RE: P-2114-WA - Priest Rapids Hydroelectric Project, Wanapum Dam Spillway Monolith No.4 – Request for approval of Interim Fish Passage Operations Plan.

Interim Fish Passage Operations Plan

Appendix C
Agency and Tribal Representative Comments/Recommendations Summary Response
Table for Interim Fish Passage Operation Plan

SECTION B
 SCALE: 3/4" = 1'-0"
 S01

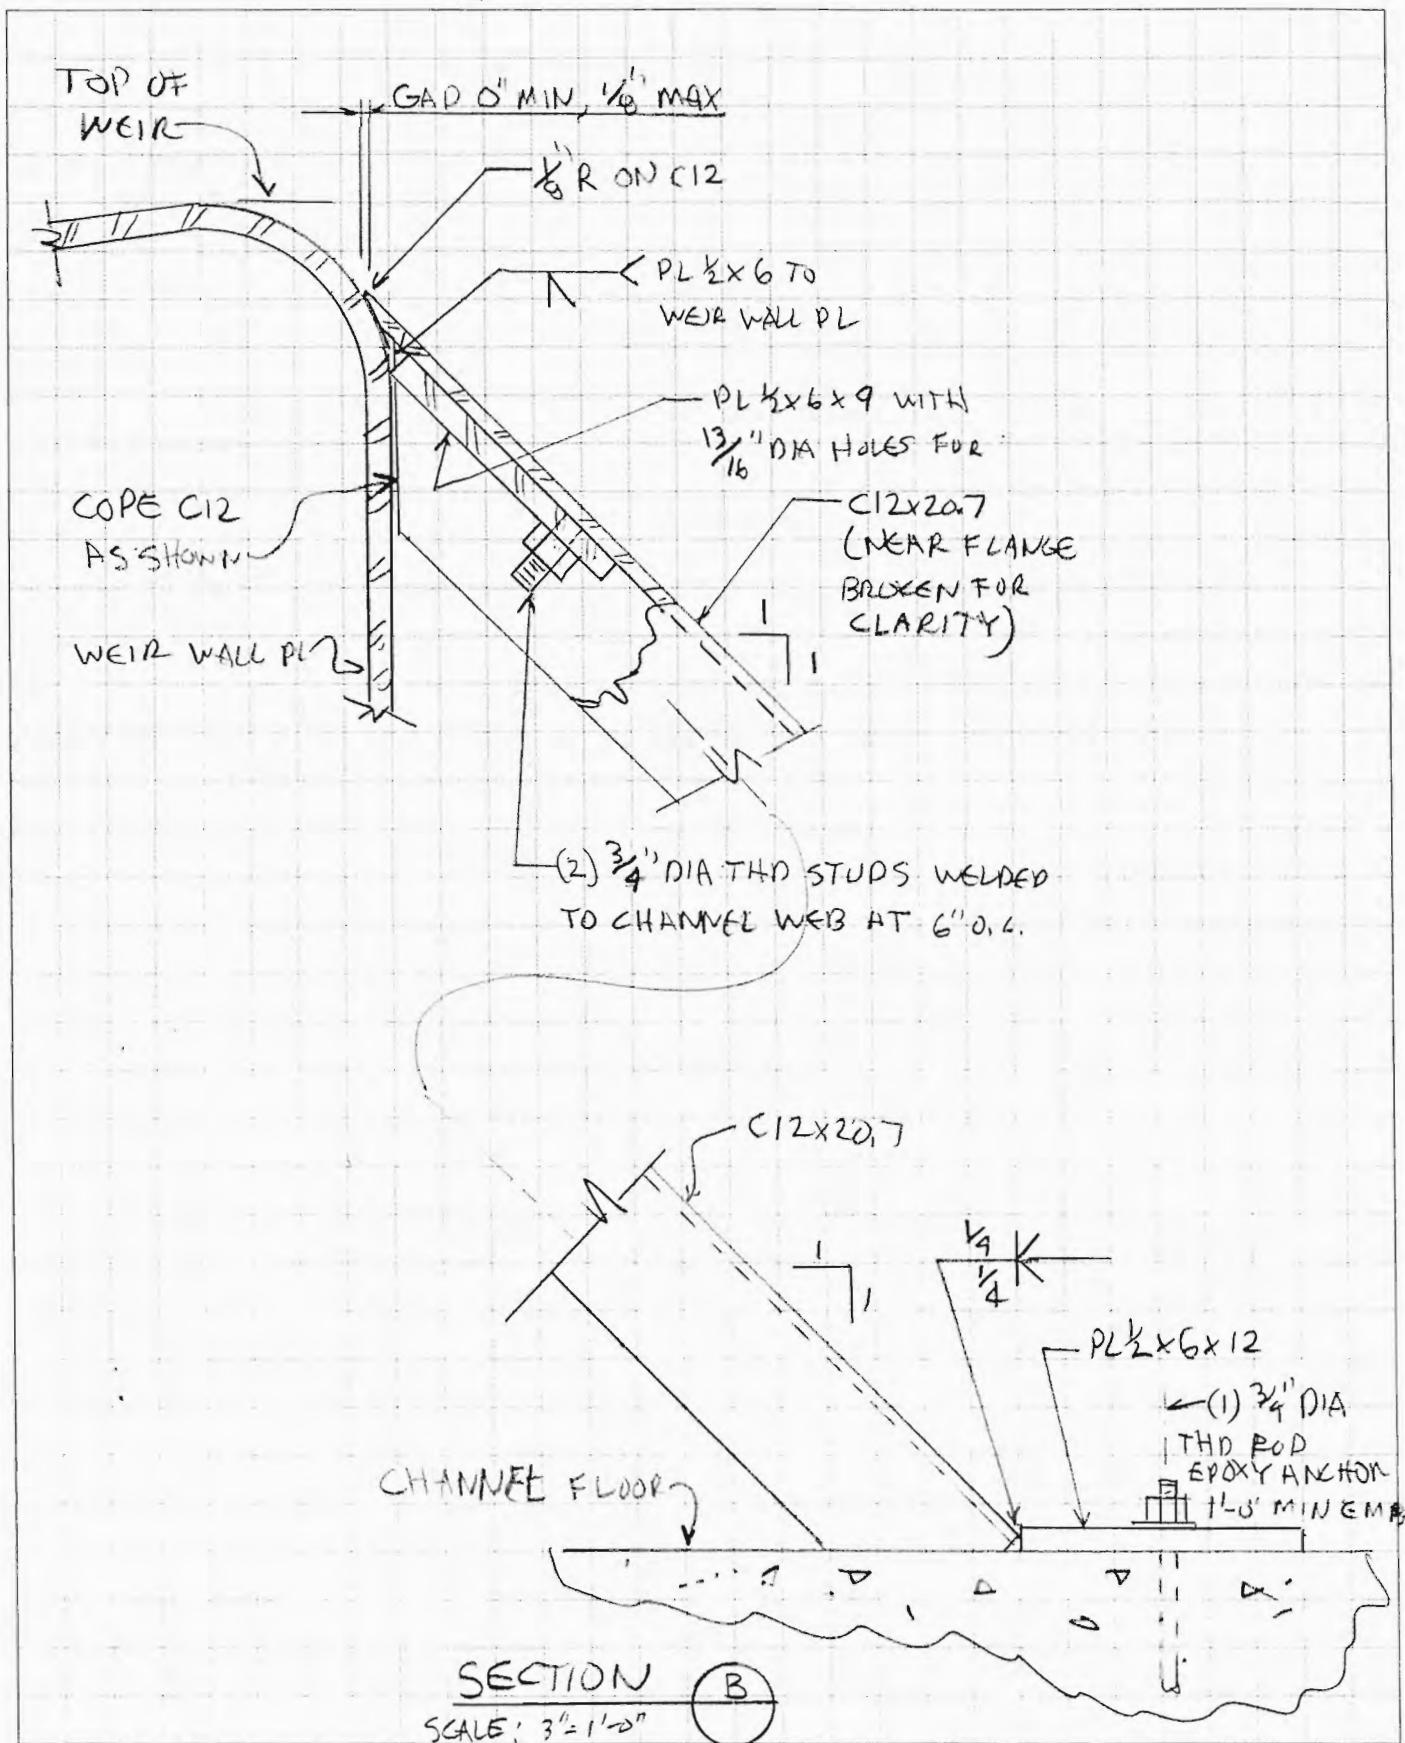
U.S. Fish & Wildlife Service	Stephen Lewis	3/14/2014	Fish ladder modifications	There are many existing designs available for spiral chute exits. Is it possible for another manufacturer to replicate this same design in some manner since it's been in existence since the early 60s?	Grant PUD is currently working with Bryan Nordlund (NOAA Fisheries) on an acceptable chute design as a contingency (Phase II) to the current design (Phase I). Designs and fabrication for both the existing design and the contingency design will move forward in parallel. The Phase I design will be installed and monitored.
U.S. Fish & Wildlife Service	Stephen Lewis	3/14/2014	Fish ladder modifications	We discussed this a bit, but what is the coating of the ramp leading to the proposed PVC chute?	Chute will be made of Fiber Reinforced Plastic (FRP). This will provide a smooth surface. This material is used in the fabrication of current fish transport tanks.

U.S. Fish & Wildlife Services	Stephen Lewis	3/14/2014	Fish ladder modifications	Is there a contingency plan in the event more makeup water is needed to execute this modification?	The upper orifice walls are designed to flow 70 cfs through two orifices. We plan to block one of the orifices in the walls all together thus requiring about 35 cfs for a 12” drop to the next orifice wall. The lower weir walls are designed to flow 30 cfs through the lower orifices and 40 cfs over the weir. We should see a full orifice and some water over the weir at this location. If more water is needed down the fish ladder, there is the ability to adjust the weir plate.

U.S. Fish & Wildlife Service	Stephen Lewis	3/14/2014	Fish ladder modification	It's assumed this modification will function at forebay elevations ranging from 541'(3)-560'(58)?	The elevation of the fish ladder exit is 554'. Once the forebay reaches elevation 551' we will need to remove the weir and chute and the orifice blocking plates then continue to raise the forebay to 560-562'. This will require a short outage to remove the equipment.
U.S. Fish & Wildlife Service	Stephen Lewis	3/14/2014	Fish ladder modifications	The tailwater of Wanapum will likely fluctuate somewhat due to normal interim operations and Hanford Reach protection flows, so will these operations affect the functionality of this modification?	Our auxiliary water system forebay inlet has an elevation of 525'. The system will still be able to provide adequate attraction flow into the tailrace to attract fish to the entrance. The flow curves of the auxiliary water system have been checked. We should be able to keep fish ladder entrance in compliance with current criteria, but this has not yet been tested at this forebay elevation.

U.S. Fish & Wildlife Service	Stephen Lewis	3/14/2014	Fish ladder modifications	We encourage any rounding corners that may be possible during this modification to encourage lamprey passage in the event spillway repairs take longer than expected and extend into the lamprey passage timeframe.	We have designed lamprey ramps up and over the weir and will radius corners to reduce impacts to fish/lamprey passage.
U.S. Fish & Wildlife Service	Stephen Lewis	3/18/2014	Salmon & Steelhead	We understand that a "false weir" structure and accompanying ramp will be used at Wanapum Dam to convey fish upstream into the Wanapum forebay at its current water elevation ranging from 541 feet to 543 feet. The Plan does not clearly state whether or not a transition chute will be used during the initial installation to minimize injury to fish. We recommend installing this	Grant PUD is working with Bryan Nordlund (NOAA Fisheries) as the Priest Rapids Coordinating Committee technical expert on a two-phase approach. Wanapum Dam ladder Phase I is installation of the current flume system design that will have an exit elevation of 554'. With a forebay operating range of 541' to 545', the maximum vertical drop fish would encounter would be 13'. Grant PUD has also provided B. Nordlund with a report on adult salmon dropped from 35' with 100% survival. Based on observational data and in consultation with NOAA and USFWS, a decision will be made on whether to proceed with an alternative design (Wanapum Dam ladder Phase II).

- We understand that a "false weir" structure and accompanying ramp will be used at Wanapum Dam to convey fish upstream into the Wanapum forebay at its current water elevation ranging from 541 feet to 543 feet. The Plan does not clearly state whether or not a transition chute will be used during the initial installation to minimize injury to fish. We recommend installing this transition chute extension during initial installation rather than deferring this action further into the various fish passage timeframes. This chute should be designed to minimize the impact to fish below the 25 feet per second threshold as they enter the forebay at its current water elevation.

- While we appreciate Grant PUD's efforts to modify the false weir to convey adult lamprey upstream of Wanapum Dam, the likelihood of 100% passage is not guaranteed. We foresee lamprey ascending the weir and collecting on the transition ramp, and not necessarily sliding into the forebay at its current location. As such, we recommend Grant PUD personnel collect lamprey at this location and convey upstream depending on the functionality of the upstream fish passage modifications at the Rock Island Dam.
- Due to the high level of uncertainty associated with lamprey passage at the Project at this time, we recommend Grant PUD begin the development of a trapping program to convey lamprey above the Rock Island Dam.
